OAG RESPONDER

BENDER		210' OIL SPILL RESPONSE VESSEL	
Bender Engineering & Design Co., Inc.		GENERAL ARRANGEMENTS	
1031-1034		H 25390	
C-02193		210SR-001-801-02	
APV/08-22-91		G	
APV/08-22-91		SHEET 1 OF 1

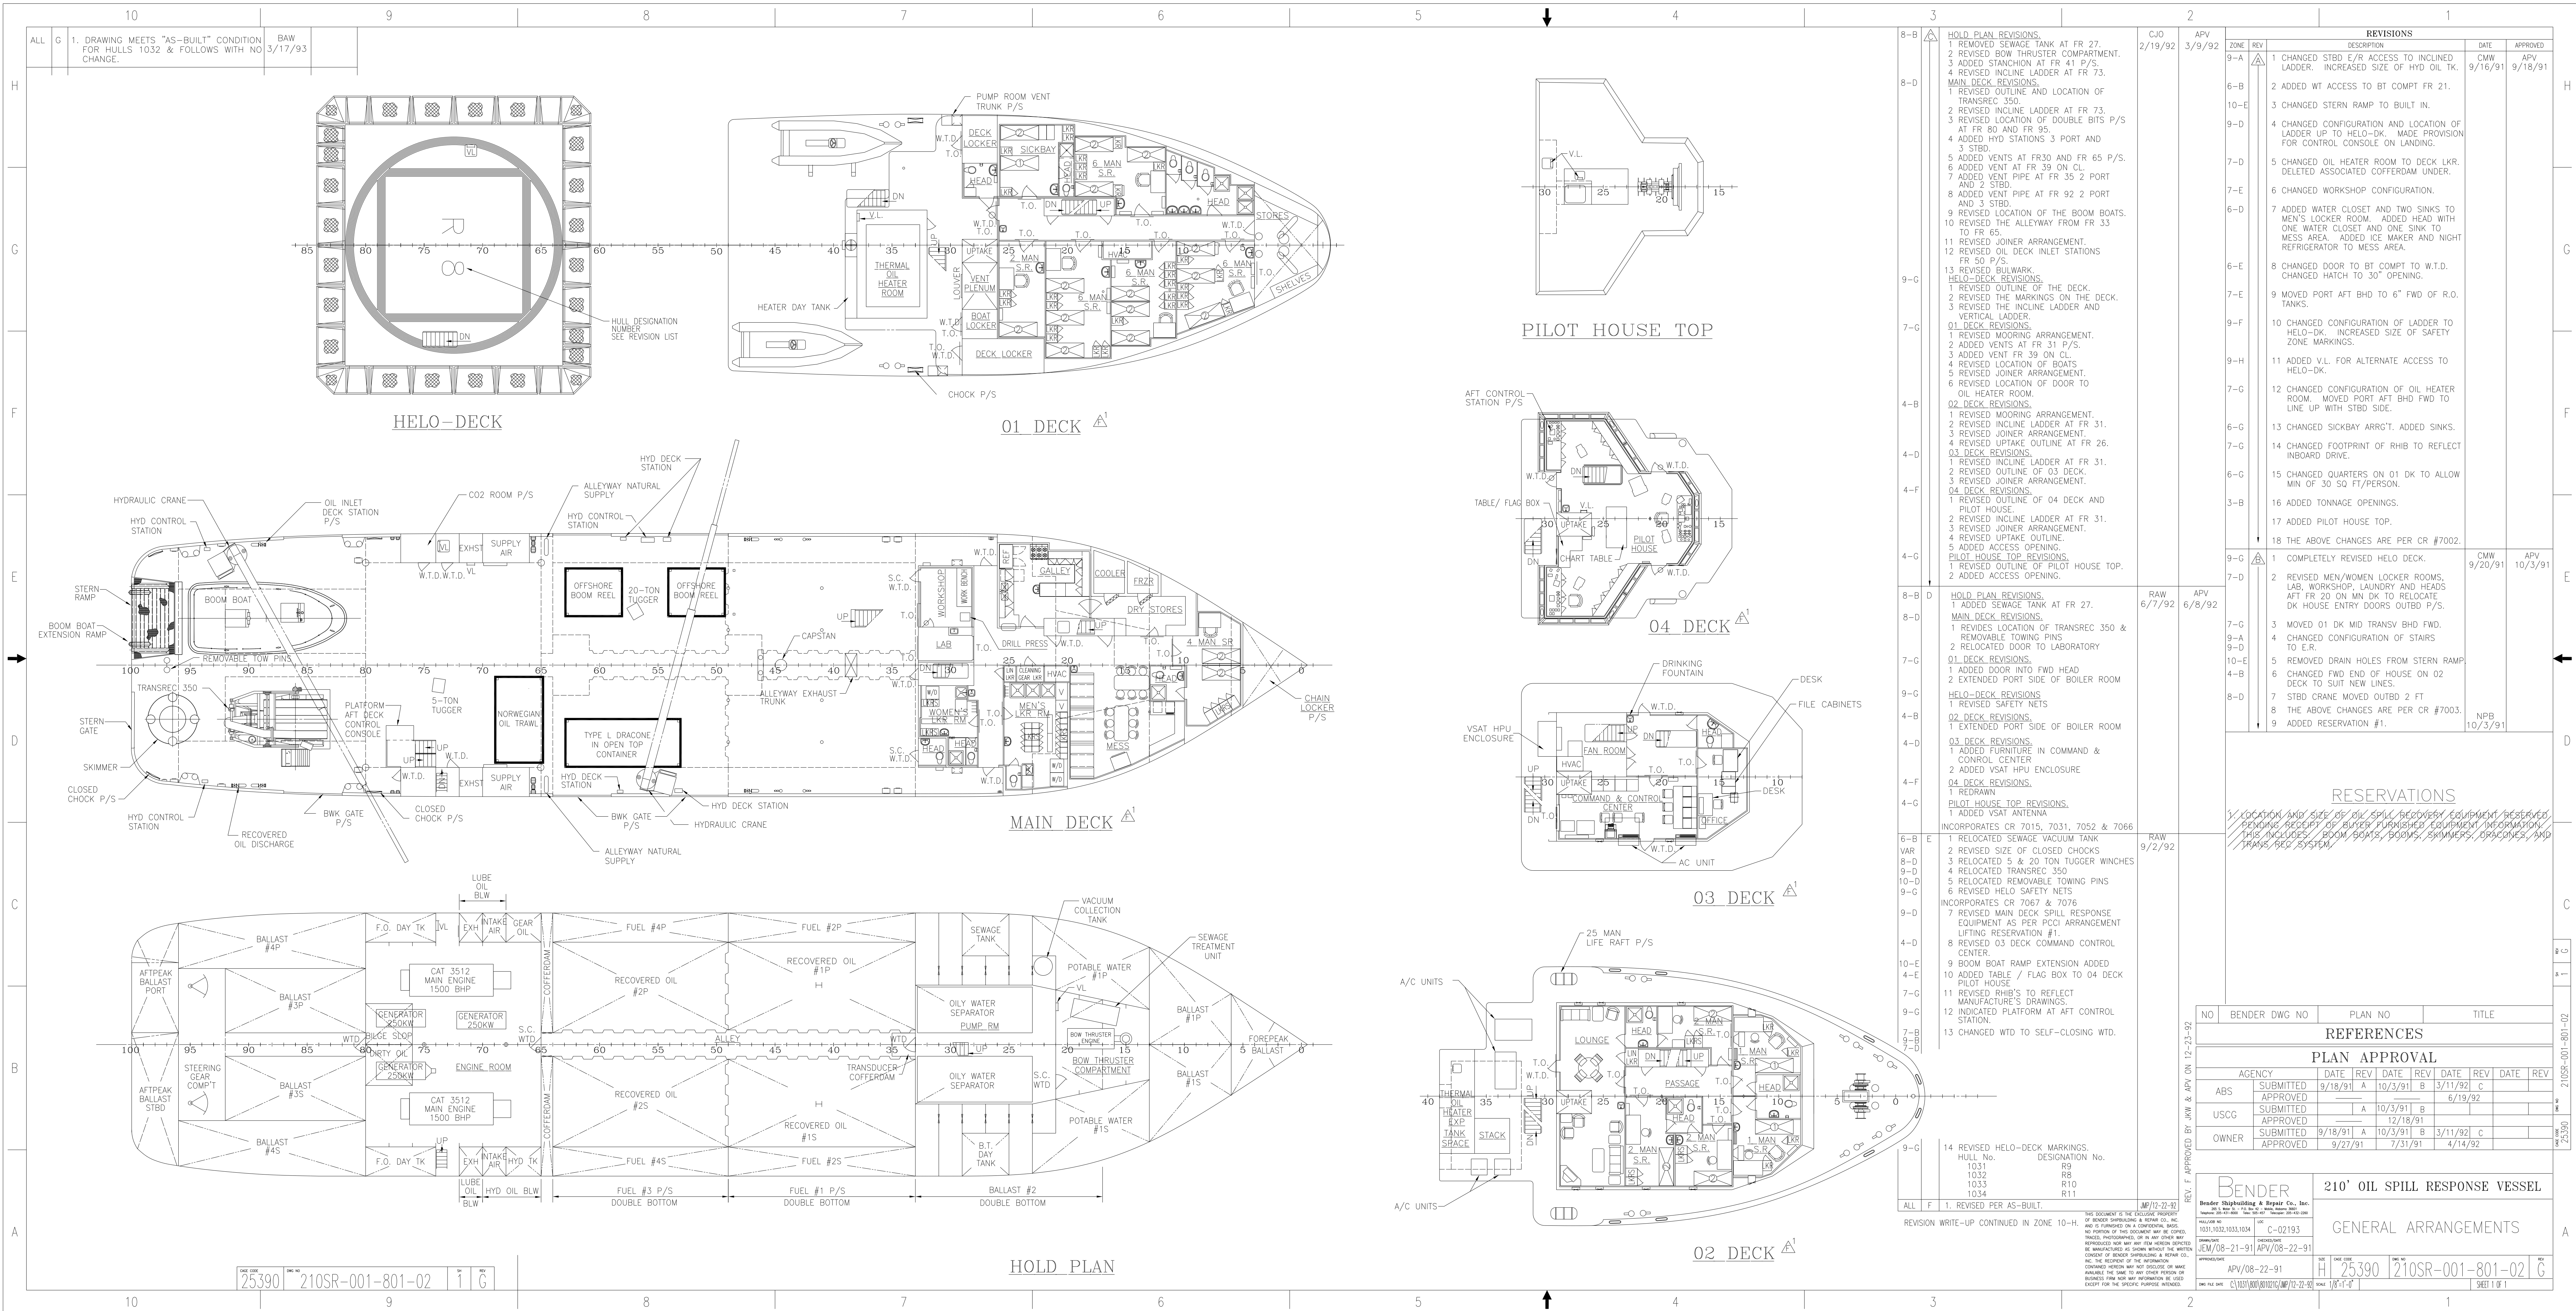
- 8-B 1. HOLD PLAN REVISIONS.
2. REMOVED SEWAGE TANK AT FR 27.
3. REMOVED BOW THRUSTER COMPARTMENT.
4. ADDED STANCHION AT FR 41 P/S.
5. REVISOR INCLINE LADDER AT FR 73.

6. MAIN DECK REVISIONS.
7. REVISOR OUTLINE AND LOCATION OF TRANSCREC 350.
8. REVISOR INCLINE LADDER AT FR 73.
9. REVISOR LOCATION OF DOUBLE BITS P/S AT FR 80 AND FR 85.

10. ADDED W/L STATIONS 3 PORT AND 3 STBD.
11. ADDED VENTS AT FR 30 AND FR 65 P/S.
12. ADDED VENT PIPE AT FR 35 2 PORT AND 2 STBD.
13. ADDED VENT PIPE AT FR 92 2 PORT AND 2 STBD.

14. REVISOR LOCATION OF THE BOOM BOATS.
15. REVISOR THE ALLEYWAY FROM FR 33 TO FR 65.
16. REVISOR JOINER ARRANGEMENT.
17. REVISOR OIL DECK INLET STATIONS FR 50 P/S.

18. REVISOR BULKWARK.
19. HELO-DECK REVISIONS.
20. REVISOR OUTLINE OF THE DECK.
21. REVISOR THE MARKINGS ON THE DECK.
22. REVISOR THE INCLINE LADDER AND VERTICAL LADDER.

23. 01 DECK REVISIONS.
24. REVISOR MOORING ARRANGEMENT.
25. ADDED VENTS AT FR 31 P/S.
26. ADDED VENT FR 39 ON CL.
27. REVISOR LOCATION OF BOATS.
28. REVISOR JOINER ARRANGEMENT.

29. REVISOR LOCATION OF DOOR TO OIL HEATER ROOM.
30. 02 DECK REVISIONS.
31. REVISOR MOORING ARRANGEMENT.
32. REVISOR INCLINE LADDER AT FR 31.
33. REVISOR JOINER ARRANGEMENT.

34. REVISOR UPTAKE OUTLINE AT FR 26.
35. 03 DECK REVISIONS.
36. REVISOR INCLINE LADDER AT FR 31.
37. REVISOR OUTLINE OF 03 DECK.
38. REVISOR JOINER ARRANGEMENT.

39. 04 DECK REVISIONS.
40. REVISOR OUTLINE OF 04 DECK AND PILOT HOUSE.
41. REVISOR INCLINE LADDER AT FR 31.
42. REVISOR JOINER ARRANGEMENT.
43. REVISOR UPTAKE OUTLINE.

44. ADDED ACCESS OPENING.
45. PILOT HOUSE TOP REVISIONS.
46. REVISOR OUTLINE OF PILOT HOUSE TOP.
47. ADDED ACCESS OPENING.
- 8-B 1. HOLD PLAN REVISIONS.
2. ADDED SEWAGE TANK AT FR 27.

3. MAIN DECK REVISIONS.
4. REVISOR LOCATION OF TRANSCREC 350 & REMOVABLE TOWING PINS.
5. RELOCATED DOOR TO LABORATORY.
6. 01 DECK REVISIONS.
7. REVISOR DOOR INTO FWD HEAD.

8. EXTENDED PORT SIDE OF BOILER ROOM.
9. HELO-DECK REVISIONS.
10. REVISOR SAFETY NETS.
11. 02 DECK REVISIONS.
12. EXTENDED PORT SIDE OF BOILER ROOM.
13. 03 DECK REVISIONS.

14. ADDED FURNITURE IN COMMAND & CONTROL CENTER.
15. ADDED VSAT HPU ENCLOSURE.
16. 04 DECK REVISIONS.
17. REDRAWN.
18. PILOT HOUSE TOP REVISIONS.
19. ADDED VSAT ANTENNA.

20. INCORPORATES CR 7015, 7031, 7052 & 7066.
21. 1. RELOCATED SEWAGE VACUUM TANK.
22. REVISOR SIZE OF CLOSED CHOCKS.
23. RELOCATED 5 & 20 TON TUGGER WINCHES.

24. RELOCATED TRANSCREC 350.
25. RELOCATED REMOVABLE TOWING PINS.
26. REVISOR HELO SAFETY NETS.
27. INCORPORATES CR 7067 & 7076.
28. REVISOR MAIN DECK SPILL RESPONSE EQUIPMENT AS PER PCD ARRANGEMENT.

29. LIFTING RESERVATION #1.
30. REVISOR 03 DECK COMMAND CONTROL CENTER.
31. BOOM BOAT RAMP EXTENSION ADDED.
32. ADDED TABLE / FLAG BOX TO 04 DECK PILOT HOUSE.

33. REVISOR RHHS TO REFLECT MANUFACTURE'S DRAWINGS.
34. NOTICED PLATFORM AT AFT CONTROL STATION.
35. CHANGED WTD TO SELF-CLOSING WTD.
14. REVISOR HELO-DECK MARKINGS.
HULL No. DESIGNATION No.
1031 R8
1032 R9
1033 R10
1034 R11

- ALL F 1. REVISED PER AS-BUILT.

REVISIONS		DATE	APPROVED
ZONE	DESCRIPTION	DATE	APPROVED
9-A	1 CHANGED STBD E/R ACCESS TO INCLINED LADDER. INCREASED SIZE OF HYD OIL TK.	9/16/91	CMW
6-B	2 ADDED WT ACCESS TO BT COMPT FR 21.	9/16/91	APV
10-E	3 CHANGED STERN RAMP TO BUILT IN.		
9-D	4 CHANGED CONFIGURATION AND LOCATION OF LADDER UP TO HELO-DK. MADE PROVISION FOR CONTROL CONSOLE ON LANDING.		
7-D	5 CHANGED OIL HEATER ROOM TO DECK LKR. DELETED ASSOCIATED COFFERDAM UNDER.		
7-E	6 CHANGED WORKSHOP CONFIGURATION.		
6-D	7 ADDED WATER CLOSET AND TWO SINKS TO MEN'S LOCKER ROOM. ADDED HEAD WITH ONE WATER CLOSET AND ONE SINK TO MESS AREA. ADDED ICE MAKER AND NIGHT REFRIGERATOR TO MESS AREA.		
6-E	8 CHANGED DOOR TO BT COMPT TO W.T.D. CHANGED HATCH TO 30" OPENING.		
7-E	9 MOVED PORT AFT BHD TO 6" FWD OF R.O. TANKS.		
9-F	10 CHANGED CONFIGURATION OF LADDER TO HELO-DK. INCREASED SIZE OF SAFETY ZONE MARKINGS.		
9-H	11 ADDED V.L. FOR ALTERNATE ACCESS TO HELO-DK.

7-G	12 CHANGED CONFIGURATION OF OIL HEATER ROOM. MOVED PORT AFT BHD FWD TO LINE UP WITH STBD SIDE.		
6-G	13 CHANGED SICKBAY ARRGT. ADDED SINKS.		
7-G	14 CHANGED FOOTPRINT OF RHIB TO REFLECT INBOARD DRIVE.		
6-G	15 CHANGED QUARTERS ON 01 DK TO ALLOW MIN OF 30 SQ FT/PERSON.		
3-B	16 ADDED TONNAGE OPENINGS.		
	17 ADDED PILOT HOUSE TOP.		
9-G	18 THE ABOVE CHANGES ARE PER CR #7002.		
7-D	1 COMPLETELY REVISED HELO DECK.	9/20/91	CMW
	2 REVISED MEN/WOMEN LOCKER ROOMS, LAB, WORKSHOP, LAUNDRY AND HEADS AFT FR 20 ON MN DK TO RELOCATE DK HOUSE ENTRY DOORS OUTBO P/S.	10/3/91	APV
7-G	3 MOVED 01 DK MID TRANSV BHD FWD.		
9-A	4 CHANGED CONFIGURATION OF STAIRS TO E.R.		
10-E	5 REMOVED DRAIN HOLES FROM STERN RAMP.		
4-B	6 CHANGED FWD END OF HOUSE ON 02 DECK TO SUIT NEW LINES.		
8-D	7 STBD CRANE MOVED OUTBO 2 FT.		
	8 THE ABOVE CHANGES ARE PER CR #7003.		
	9 ADDED RESERVATION #1.	10/3/91	NPB
